**Notice of objection to the Derrybrien Windfarm Substitute Consent
“Exceptional Circumstances” Application by the ESB PL07 308019-20**

I request An Bord Pleanála to refuse Substitute Consent to the windfarm development at Derrybrien (application No PL07 308019-20) on the basis that “exceptional circumstances” do not exist in this case.

Figure 1: Contents of Appendices as listed in the Chapter 10 Main Chapter

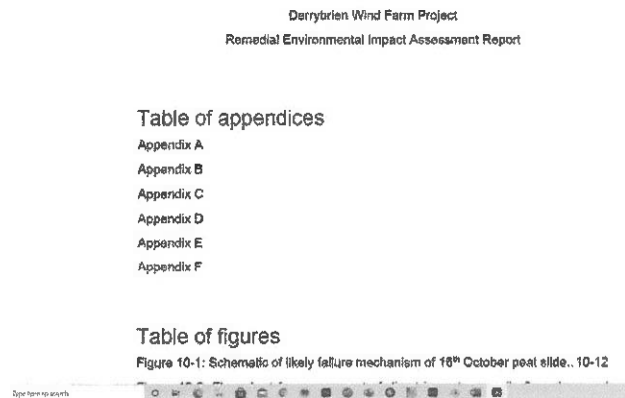
The rEIAS document provides a list of contents for the document itself, but provides no information in the Contents pages about what is contained within the Appendices (see attached Figure).

This provided list of Appendices suggests that there are six Appendices, A – F, but what these contain and what their significance might be is left to the reader to guess. Turning to the Appendix document itself (namely Chapter 10 – Soils, Geology and Land Appendices, Document No.: QS-000280-01-R460-001-000), this provides no Contents page or Index at all, other than the contents pages of the individual reports presented within the appendices – to which there is no guide at the start of the document. Furthermore, it emerges that there are not six Appendices but instead a nested multitude of Appendices, in some cases going down as far as four levels of Appendix.

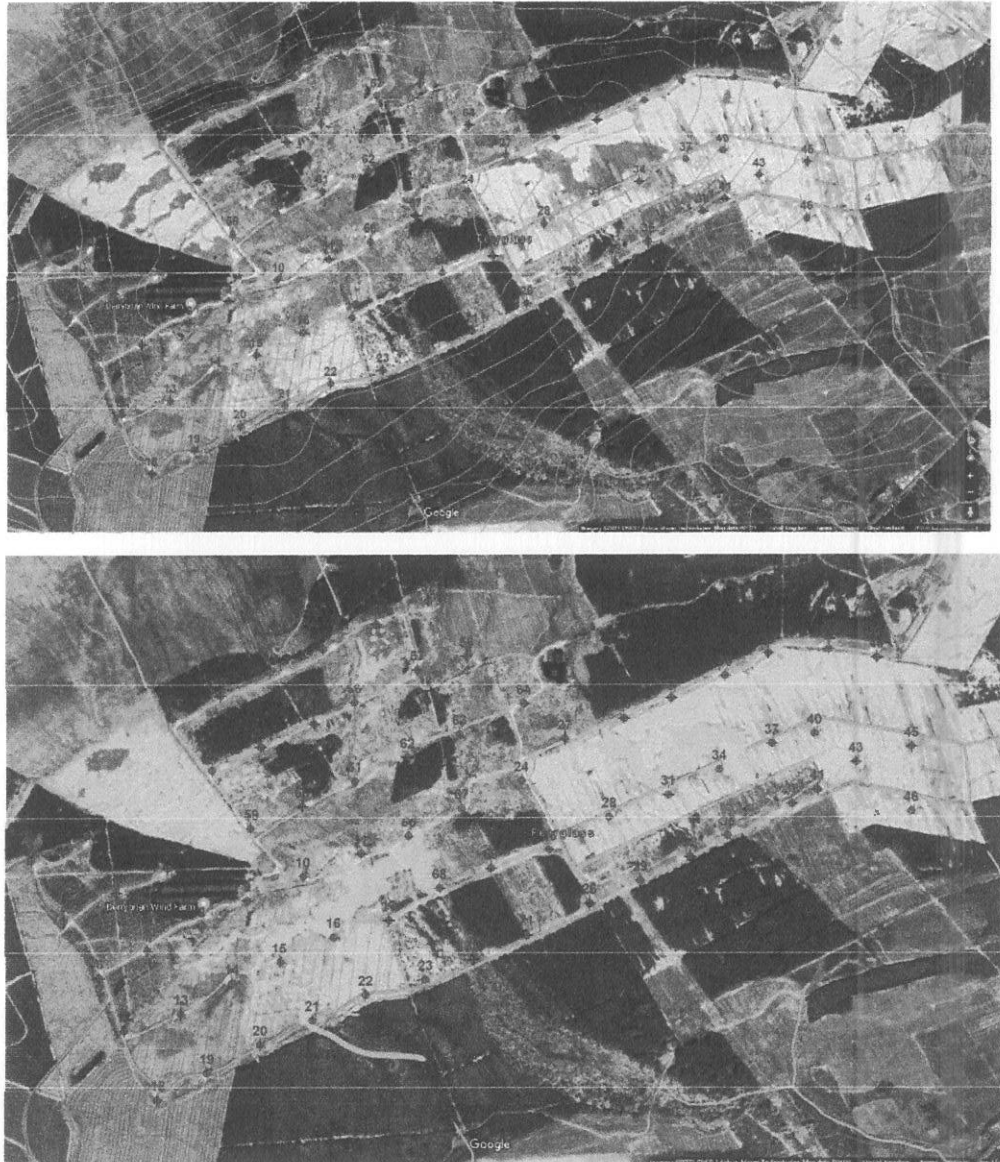
It seems likely that there is further failure in basic mapping of the ground condition in terms of how the information obtainable from aerial photography has been interpreted. With reference to the aerial photographs provided as ‘Figure 10-4 in Section 10.2.1.3’ of the REIAS and ‘Figure 2-1 of Appendix E’, the latter figure points to a dark sinuous band of colour crossing the turbary area and describes it as ‘*deep peat along subsurface drainage channel*’ which is undoubtedly the case, given the sinuous nature of the dark shading.

A similar band of sinuous shading which forms a huge crescentic shape leading down into the same ‘shallow valley’ which experienced the 2003 peat slide (see Figure 2) is merely identified (along with others) as an ‘*Area of deeper peat and high water table on flat terraces (Darker vegetation)*’ but with no mention of the (very likely) possibility that this, too, is an area of sub-surface piping and/or seepage. Furthermore, the dark zones identified in the NW corner of the aerial photograph and lying just outside the windfarm boundary actually point downslope and converge on a natural drainage line, so it is possible that these, too, are seepage zones or areas of sub-surface piping.

Further areas of dark ground can just be discerned vanishing into the forest blocks within the windfarm site, so it is possible that sub-surface seepage is widespread within the site. These may be natural zones of seepage, but published evidence from, for example, Holden *et al.* (2002) and Holden (2005) have identified a clear linkage between drying peatlands and prevalence of sub-surface piping.

It should also be noted that the heads of the pale blue seepage zones in Figure 2 all begin along the line from Turbines 27 to Turbine 42.

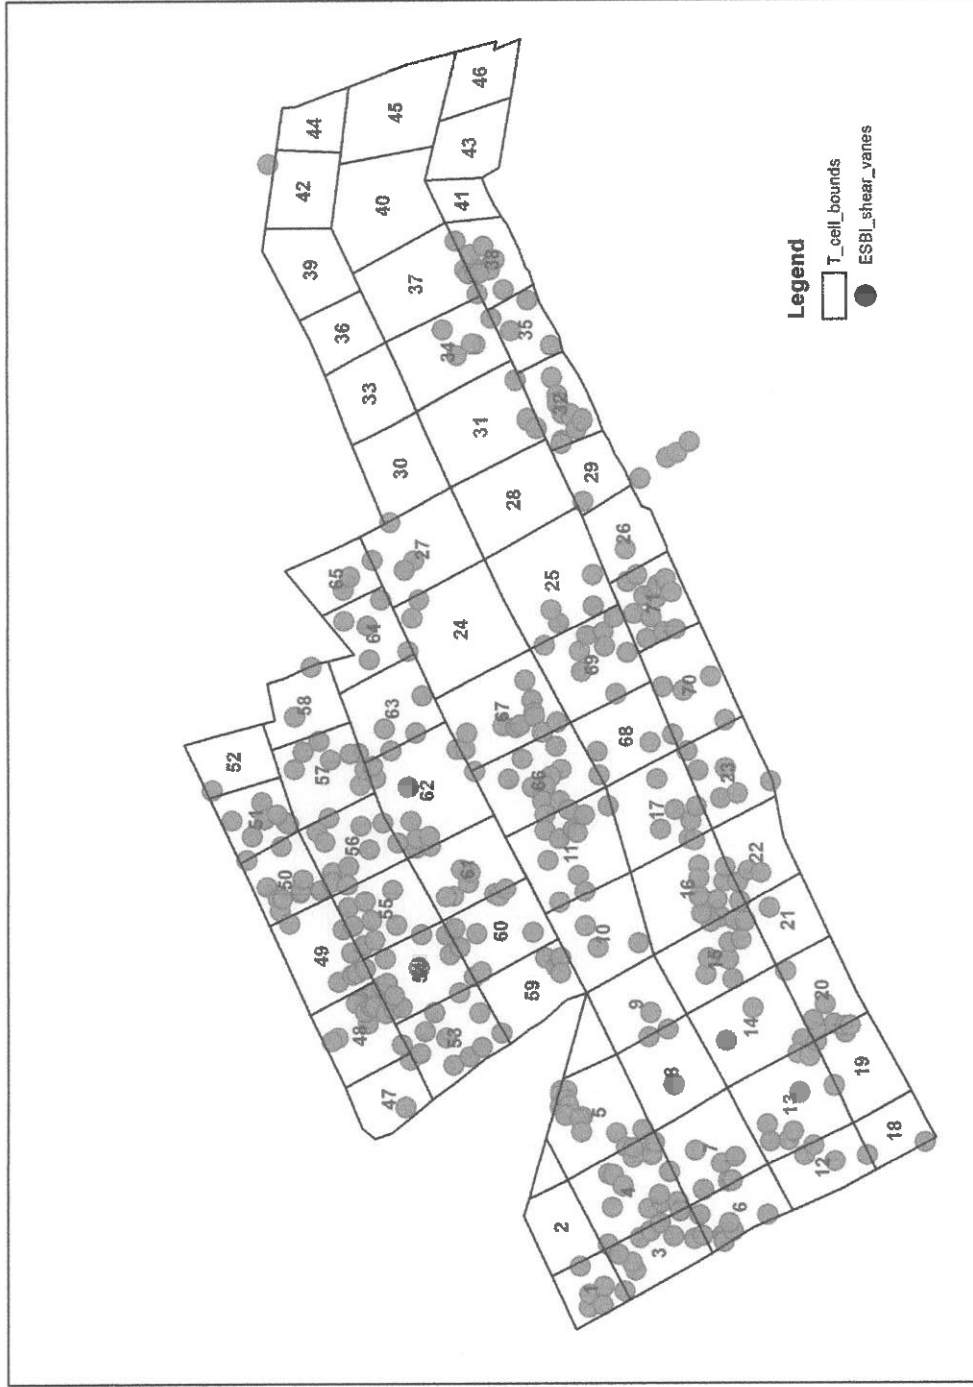
Secondly, the FoS calculation for each T-cell was based on testing the peat in only a single location in each T-cell, and even this in only a proportion of the full set of T-cells (see Figure 6).

Figure 8. Peat Stability Assessment by AGL (2020) for baseline conditions in 1998 for each T-cell. Highest risk rating is '5'. Note the concentration of high risk cells in the northern section of the site, and also the high risk value along the western margin of the site.

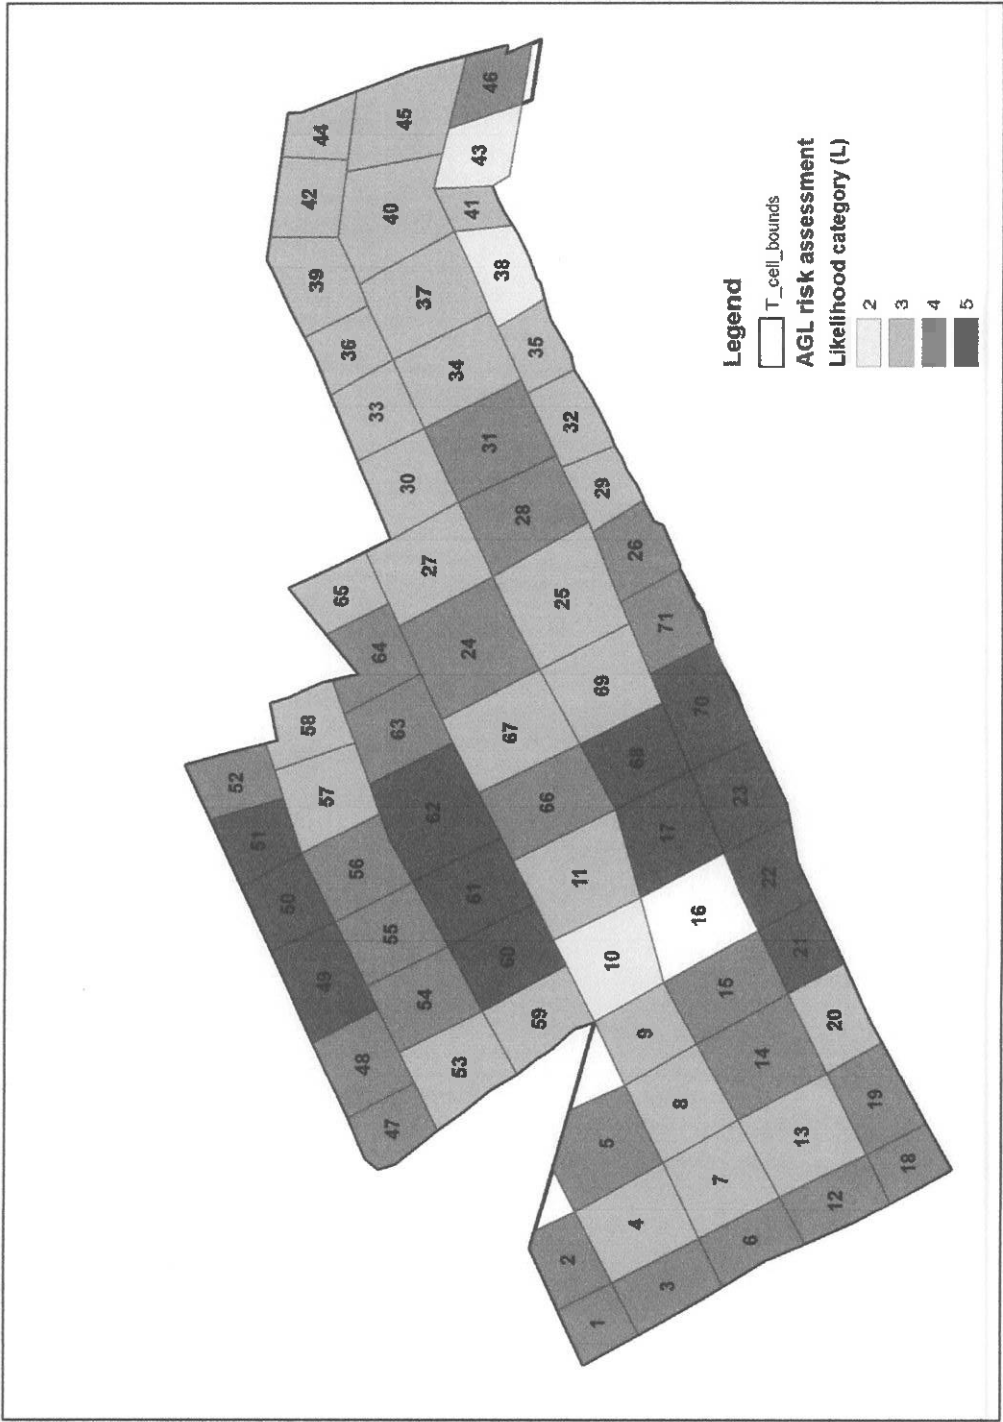
significant risk of instability and consequent impact (see Figure 8). The distribution of shear vane tests in relation to this assessment can be seen in Figure 9, while correspondence with the original 'worst-case' map generated by AGECE (2004) can be seen in Figure 10.

What is most striking about the areas identified as being at risk in by AGECE (2020) is the clear concentration of T-cells at risk in the northern sector of the site, mirroring the already-failed area of the 2003 slide to the south. This region remained largely un-surveyed by AGECE (2004) so the main records for peat condition come from ESSI (2005). Even after this survey, however, some critical T-cells remain largely un-tested, as can be seen from Figure 9. They still emerge as being significantly at risk because of other risk factors. Concentration of high-risk areas in the northern and western parts of the site is reinforced by the findings of the AGECE (2004) report, as can be seen in Figure 10.

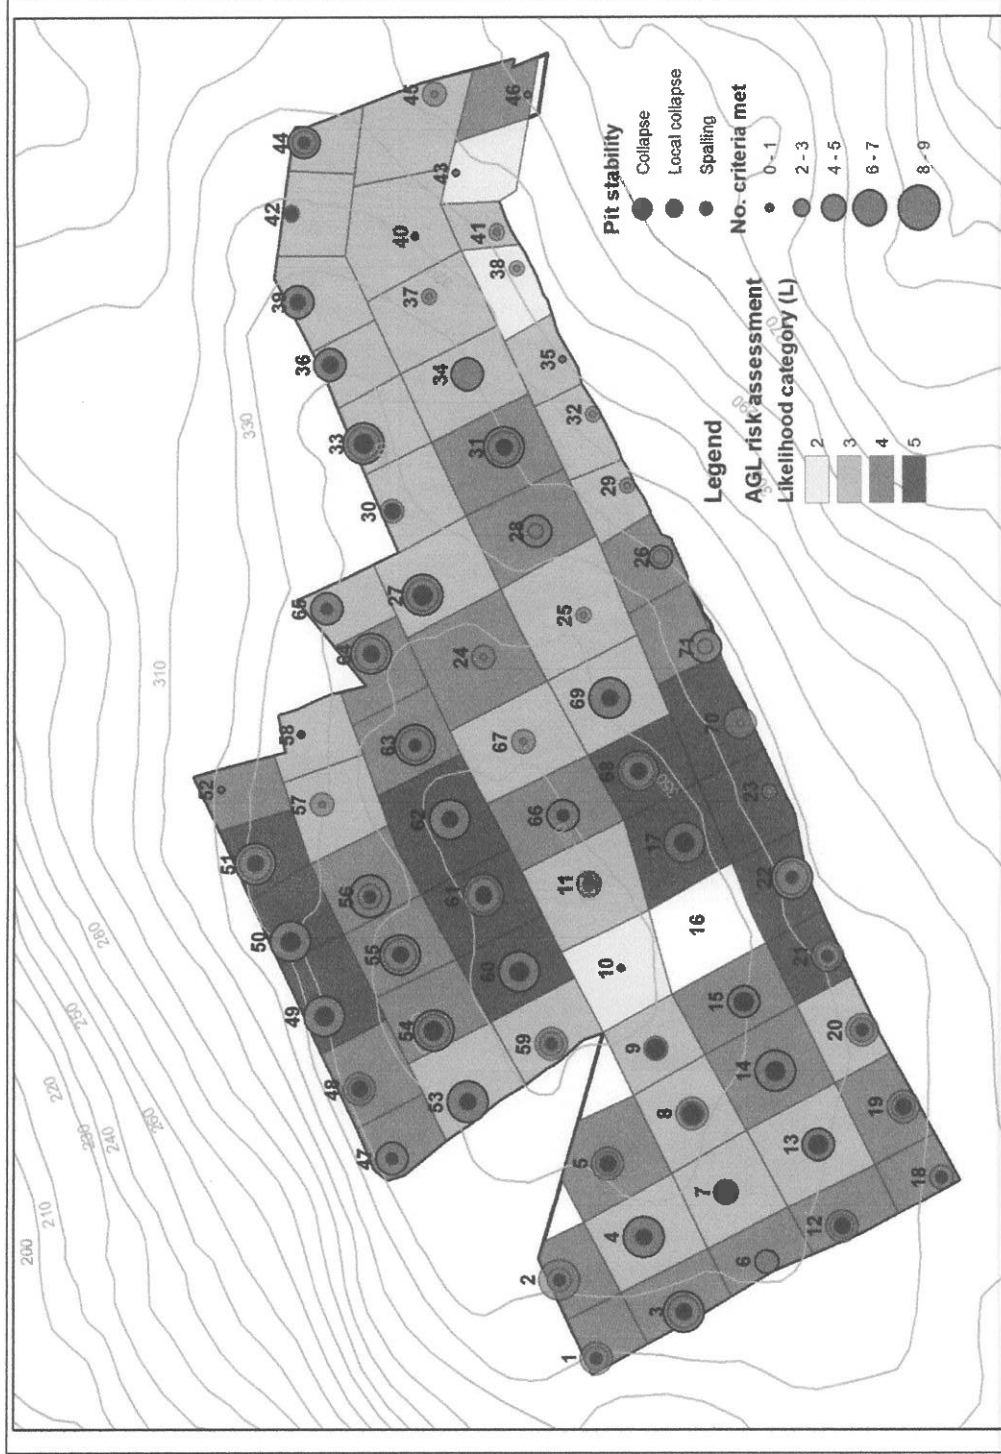
Figure 11 compares the distribution of T-cells at risk based on the data in Table 3 with the distribution of at-risk T-cells presented by the rEIAS (and shown in Figure 8 above). From this it can be seen that there is good correspondence across all those T-cells identified in the rEIAS, but the revised assessment based on the data in Table 3 highlights a number of additional T-cells.
